Errata to PowerPC™ e500 Core Family Reference Manual, Rev. 1

This errata document describes corrections to the *PowerPC™ e500 Core Family Reference Manual*, Revision 1. For convenience, the section number and page number of the errata item in the reference manual are provided. Items in bold are new since the last revision of this document.

Figure 2-13. Machine Check Address Register (MCAR/MCARU)

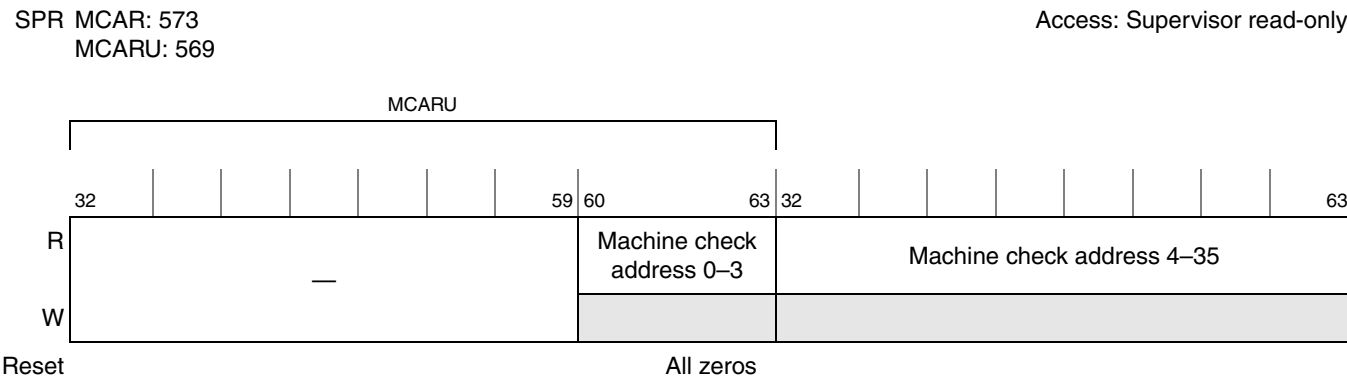
2.7.2.3, 2-22 A new register, MCARU, machine check address register upper, has been added to support 36-bit physical addressing in the e500v2 core. Replace the entire section with the following:

When the core complex takes a machine check interrupt, it updates MCAR, shown in [Figure 2-13](#), to indicate the address of the data associated with the machine check. Note that if a machine check interrupt is caused by a signal, MCAR contents are not meaningful. Errors that cause MCAR contents to be updated are implementation dependent.

In the e500v2, MCARU[60–63] contain the 4 highest-order bits of the machine check address.

Figure 2-16. Branch Buffer Target Address Register (BBTAR)

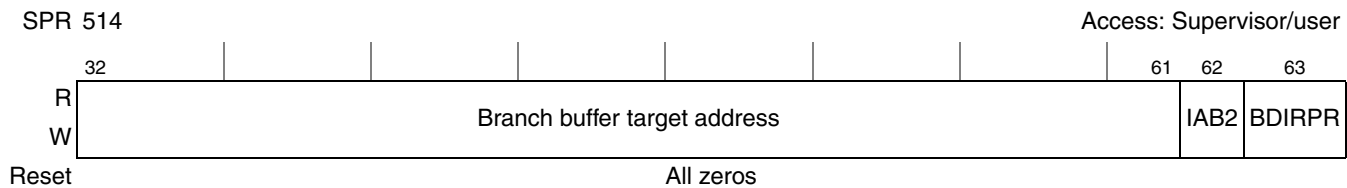
2.9.2, 2-25 The SPR of the branch buffer target address register should be 514. The register should appear in the manual as follows:

Figure 2-19. Hardware Implementation-Dependent Register 1 (HID1)

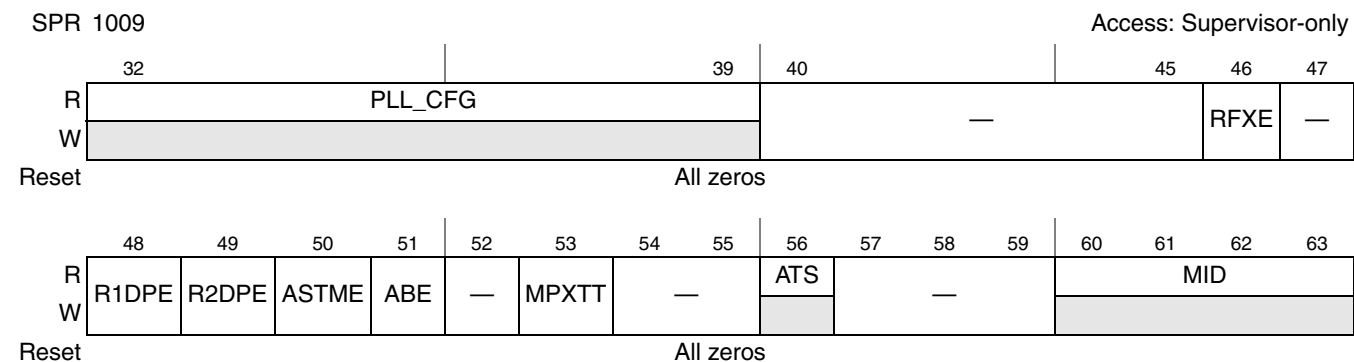
The size of HID1[PLL_CFG] is incorrectly shown. Replace the register figure and the affected rows of the field descriptions as follows:

Bits	Name	Description
32–39	PLL_CFG	Reflected directly from the PLL_CFG input pins (read-only)
40–45	—	Reserved, should be cleared.
...
